## Report to Planning and Environment Committee

**Subject:** 2134325 Ontario Inc. (York Developments)  
1407-1427 Hyde Park Road  
File Number: OZ-9438, Ward 7  
Public Participation Meeting

**Date:** October 23, 2023

Figure 3 – Conceptual Site Plan (July 2023)

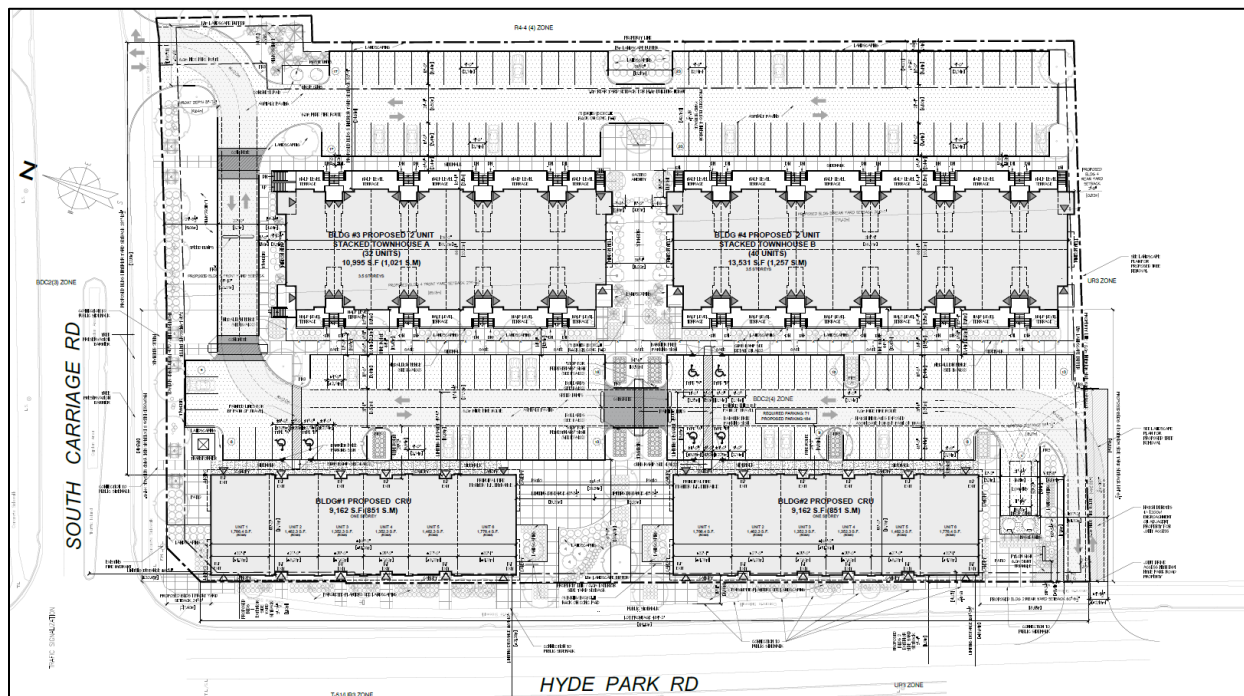
- Enlarged central amenity between Buildings 1 and 2;
- Revised building footprints (Buildings 1 to 4);
- Revised major pedestrian crossings by replacing asphalt surfacing with concrete and providing speed bumps for enhanced safety;
- Introduced pedestrian crossing signs at main crossing between commercial and residential buildings;
- Provided an iron fence with gates to act as a buffer between townhouse buildings and western parking lot;
- Reoriented Building 3 townhouse entrances to South Carriage Road (north units);
- Reduced parking spaces fronting South Carriage Road from 14 to 4 spaces, with no parking located between Building 3 and the road corridor;
- Reduced total parking provided from 177 spaces to 164 spaces;
- Removed bicycle racks from Hyde Park Road frontage;
- Proposed a location for the transformer;
- Revised elevations to reflect new building footprints.

The proposed development shows a joint access from Hyde Park Road over the adjacent property at 1369 Hyde Park Road. Transportation staff do not support this access, and further, it results in tree preservation concerns as there are several boundary trees which require written consent to remove or damage. An alternative access location and design is recommended as a consideration of the Site Plan Approval Authority.

- iv) Consent to remove any boundary trees is required prior to final Site Plan Approval;
  - v) An alternative location for site access from Hyde Park Road be considered;
